FDP - Amendment No. 1
Barefoot Lakes Filing No. 2
Planned Unit Development
COVER AND NARRATIVE
Town of Firestone
Weld County
State of Colorado
Sheet 1 of 36

BAREFOOT LAKES FILING NO. 2, AMENDMENT 1 - FINAL DEVELOPMENT PLAN

This document is an Amendment to Barefoot Lakes Filing No. 2 FDP, recorded on 2/15/2018 at Rec. #4375621 at the office of Weld County Clerk and Recorder.

The purpose of this First Amendment is to make adjustments that allow for a new community pool facility. Single Family lots have been reconfigured as part of this amendment in order to accommodate the land required for this new facility. After careful analysis of the overall Barefoot Lakes development, and the distribution of planned and existing amenities, this location has been selected for the new pool facility as it is centrally located to the parcels that are and will be located south of Ronald Reagan Blvd. Its location just off Barefoot Lakes Parkway makes it readily accessible to both the existing filings as well as to planned filings to the east.

1 SMALL AMENITY SIGN
 1/2" = 1'-0"

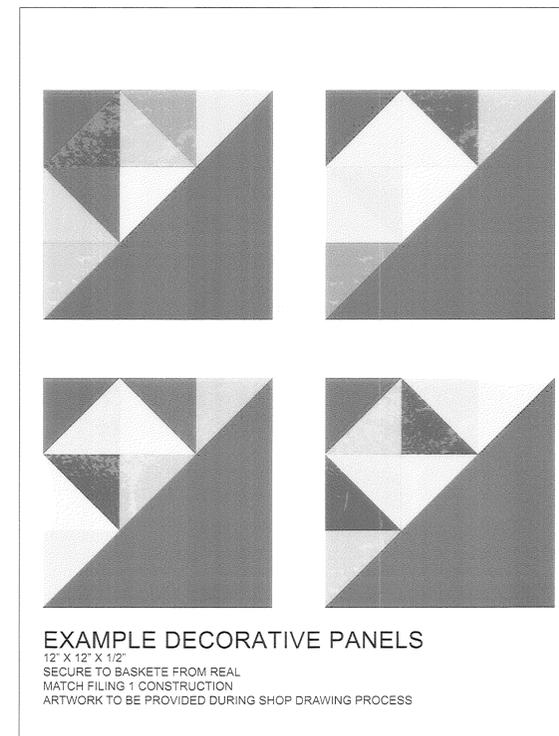
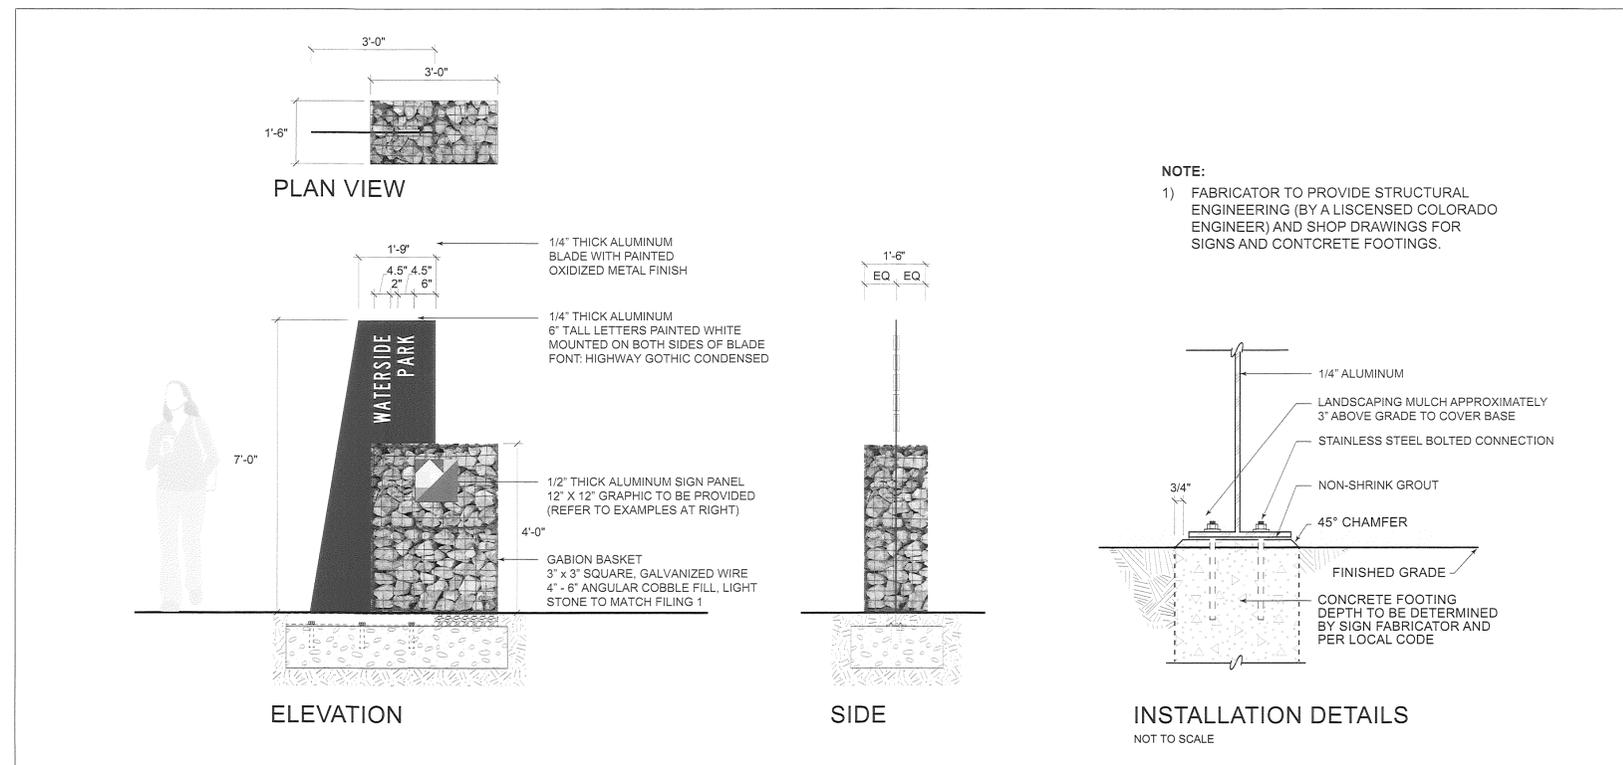
The Signage Standards remain unchanged, with the exception of one new sign type that is added at the new pool facility. Regulatory signage for the parking lot and an identity sign will be added at the new pool facility, as identified on sheet 22. Since the cul-de-sac at the end of Brook Creek Avenue has been removed, it will no longer need a street name and stop sign at the northeast corner of the intersection.
